LAKE STREET PLACE
112-150 LAKE STREET S
KIRKLAND, WA 98033

ATTACHMENT
FILE NO. DRV12-0092
MODIFICATION
APPLICANT PLAN

Lake Street Place Project

DRB Modification #2
July 16, 2015

MSB & PUBLIC WALKWAY FROM SOUTH - APPROVED 5/21/15

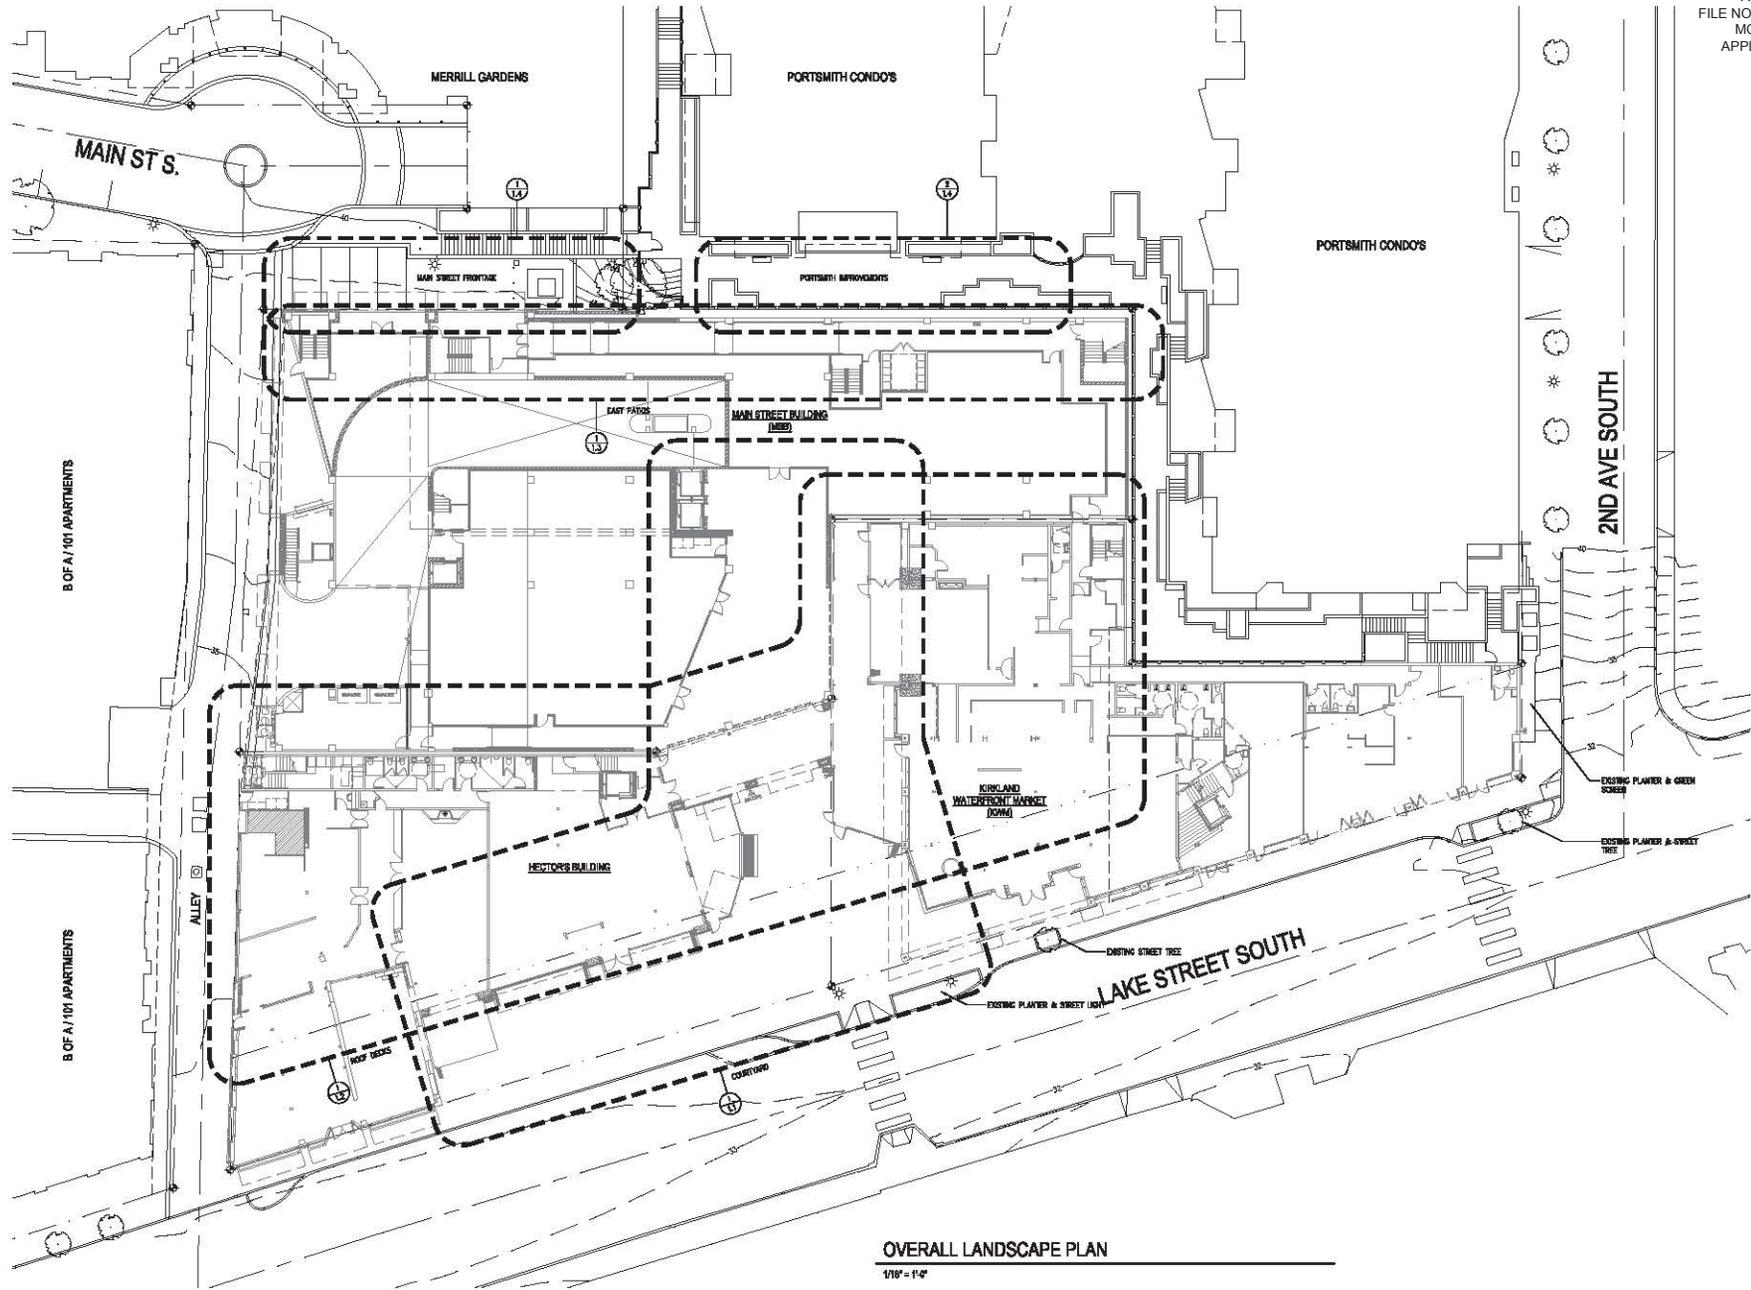
The Main Street Building (MSB) will be slightly modified to provide a deck area at the southwest corner of the 4th floor since we are removing the 4th floor of KWM. This new deck will look like the deck above on the 5th floor. Also, the Landscaping layout has been updated including: the hardscape at the covered pedestrian area, the upper west decks, and required "columnar evergreens" from the original approval conditions are proposed to be changed.

OVERALL LANDSCAPE PLAN
1/8" = 1'-0"

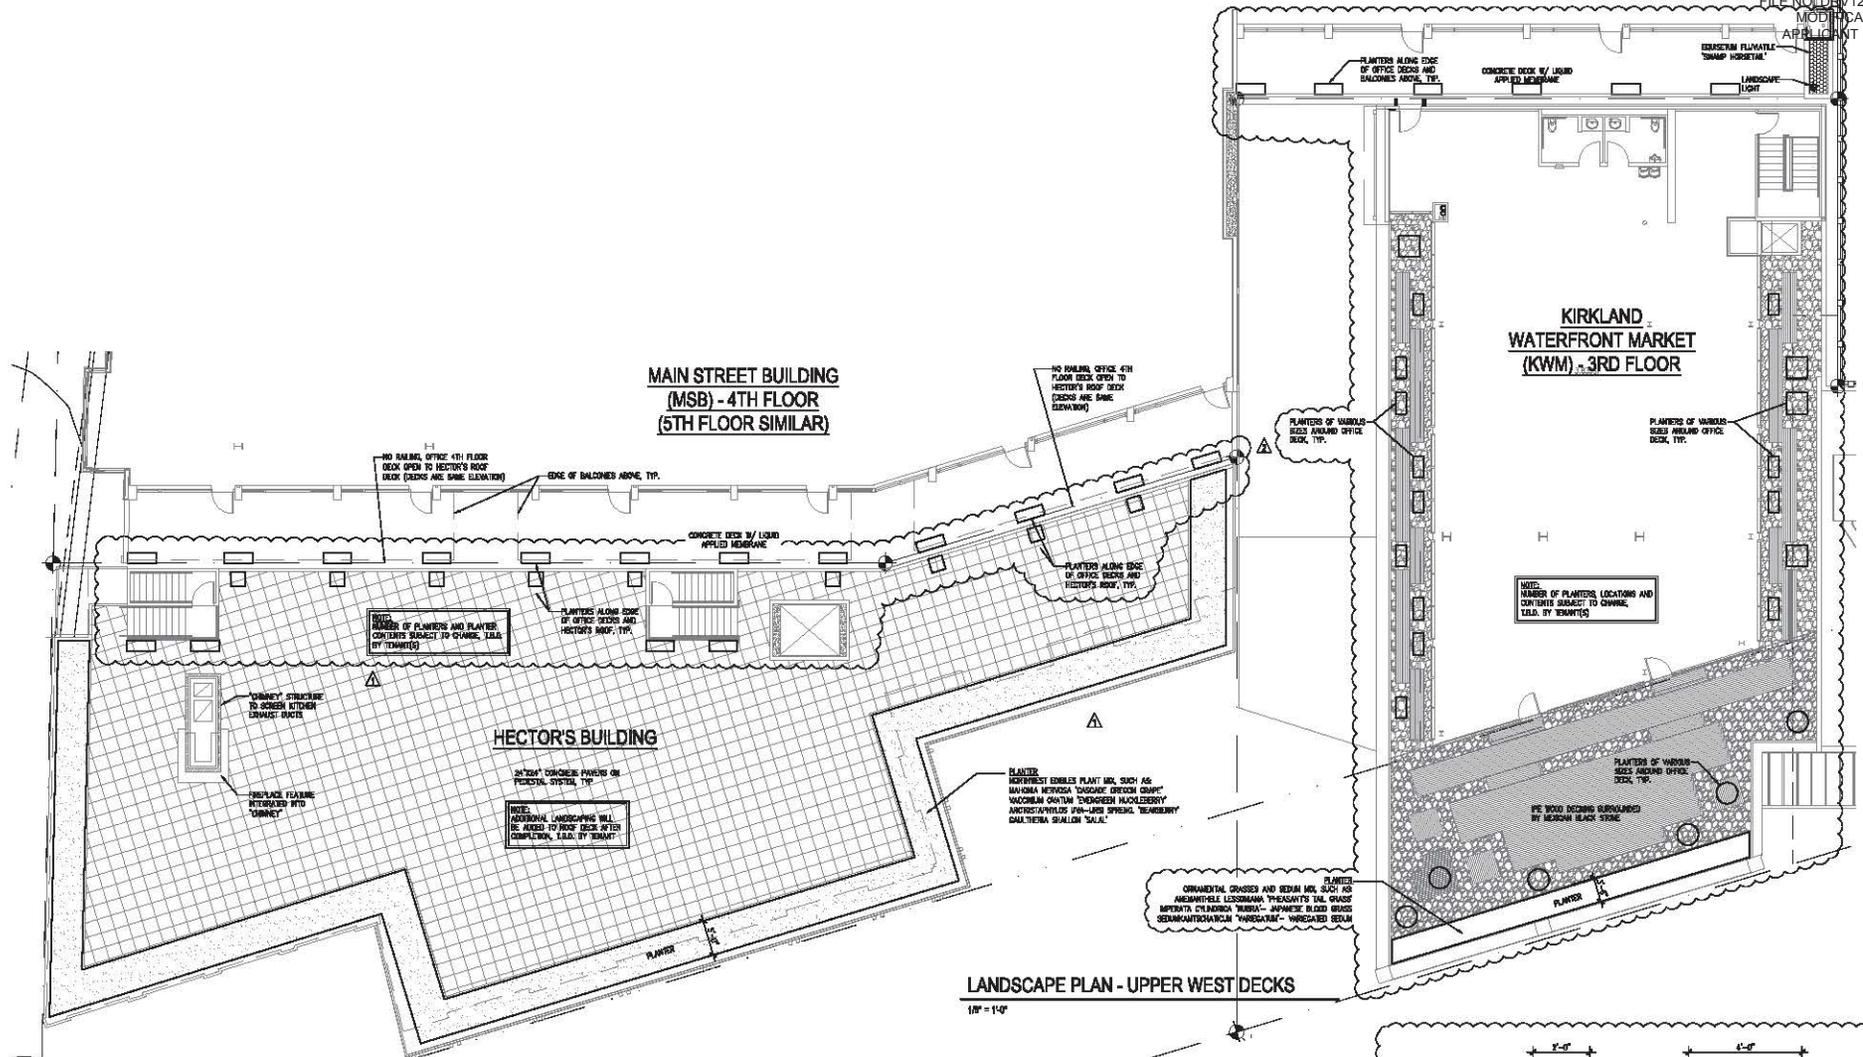
No changes are proposed to the Hector's building. The Landscaping layout has been updated including the hardscape layout at the courtyard and the planters on the roof deck.

KIRKLAND WATERFRONT MARKET (KWM) - 3RD FLOOR

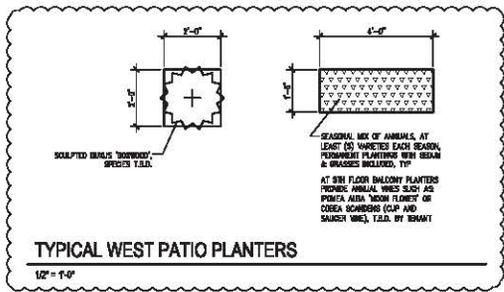
The Kirkland Waterfront Market (KWM) building design will be modified to remove the new stair and elevator towers on the north façade and the entire 4th floor and roof top deck. Furthermore, the massing of the 3rd floor will be reduced by pulling most of the north wall away from the edge of the existing building. The new look of the 3rd floor will differentiate from the existing building in the same way as the 3rd floor of the Hector's expansion differentiates from the lower 2 floors. Also, a new steel and glass "sunroom" space will be added to the north façade and fill in the 20ft wide "gap" between the KWM building and MSB building. Also, the Landscaping layout has been updated on the 3rd floor deck.
